SUBJECT: FLORIDA POWER & LIGHT COMPANY, St. Lucie Plant. Unit No. 1.

AMENDMENT TO FACILITY OPERATING LICENSE

Amendment No. 55  
License No. DPR-67

ATTACHMENT TO LICENSE AMENDMENT NO. 55  
TO FACILITY OPERATING LICENSE NO. DPR-67

Figure 6.2-1 Offsite Organization for Facility Management and Technical Support

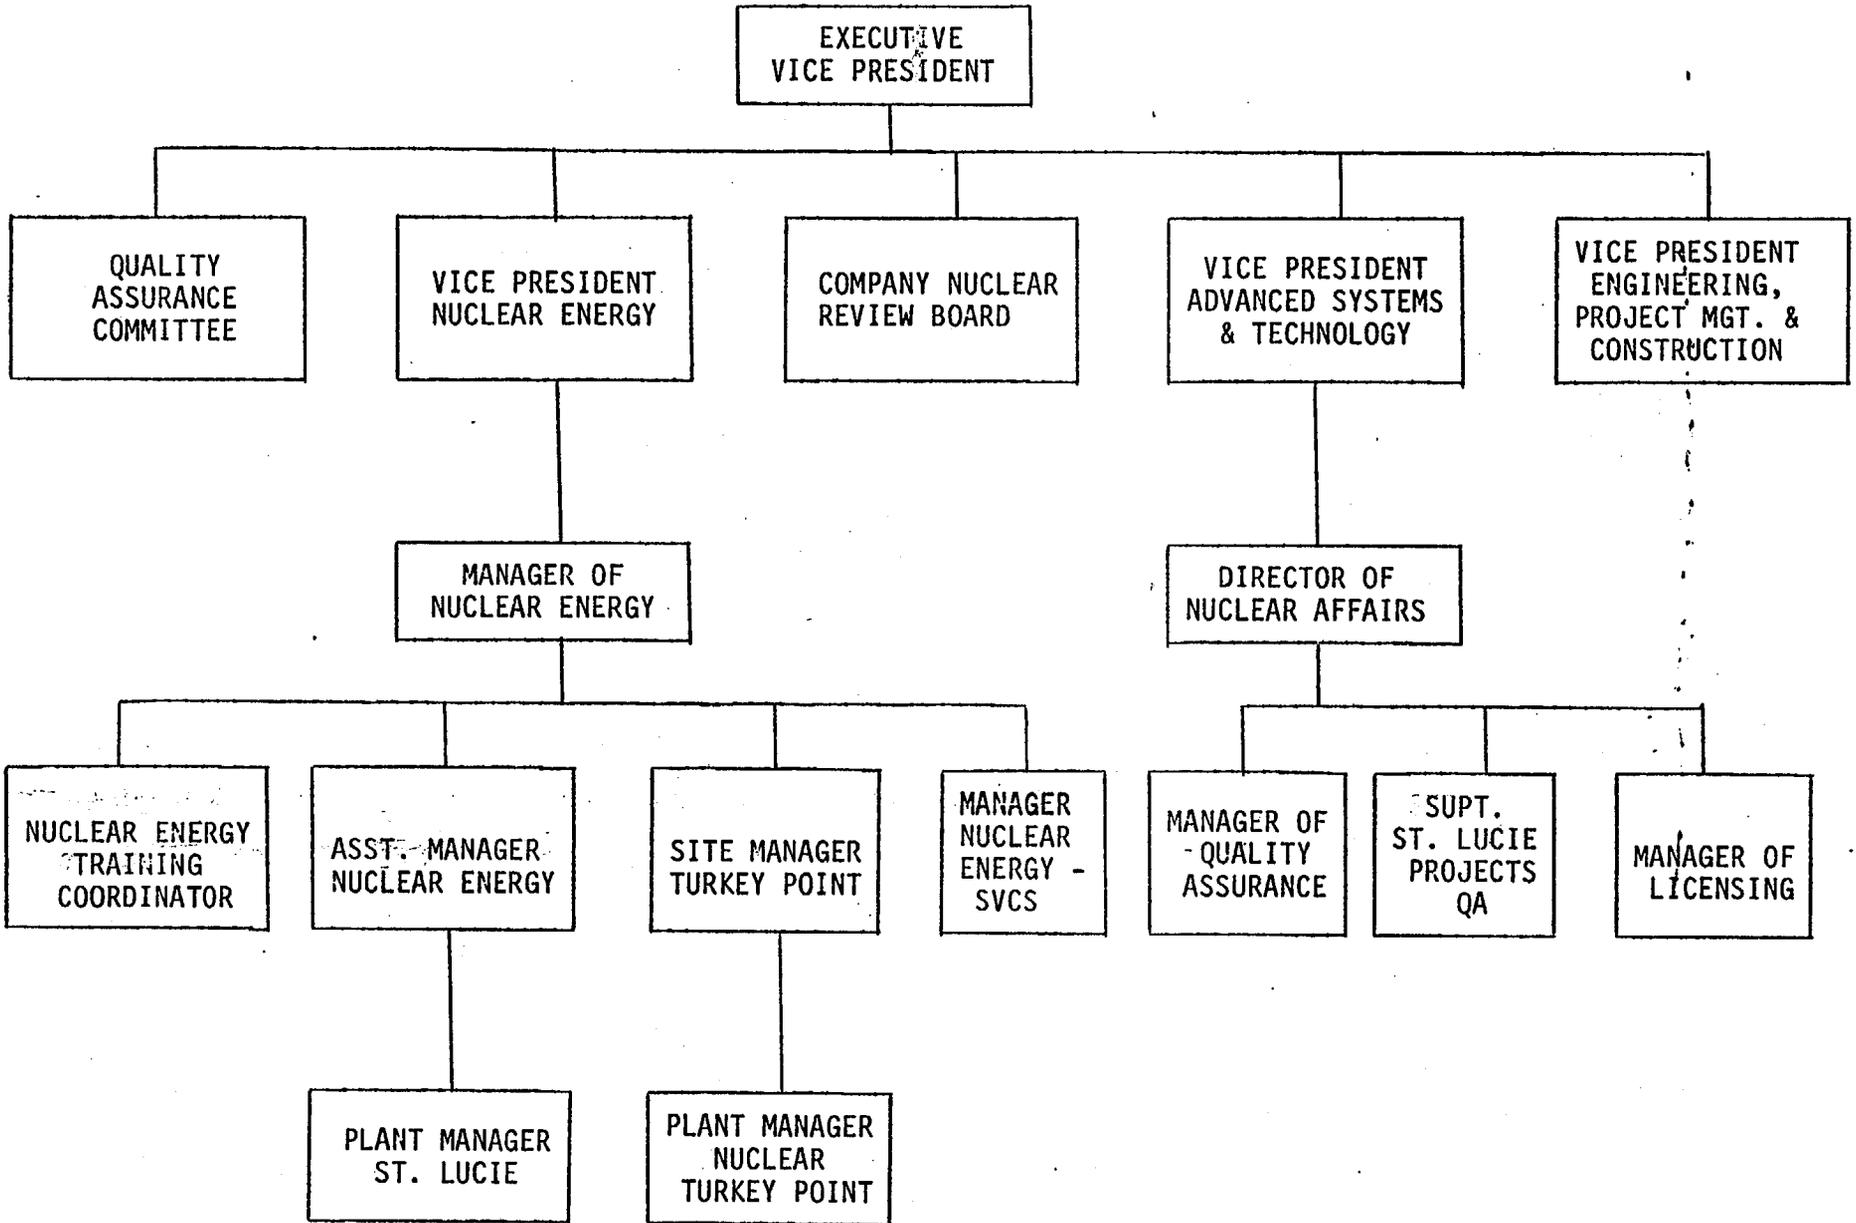
This amendment consists of updating Figures 6.2.1 (offsite organization) and 6.2.2 (facility organization) and the membership of the Company Nuclear Review Board in the Administrative Control Section of the TS.

This amendment updates the offsite and facility organization figures and the membership of the Company Nuclear Review Board in the Administrative Controls section of the Technical Specifications.

6.2.1 The offsite organization for facility management and technical support shall be as shown on Figure 6.2-1.
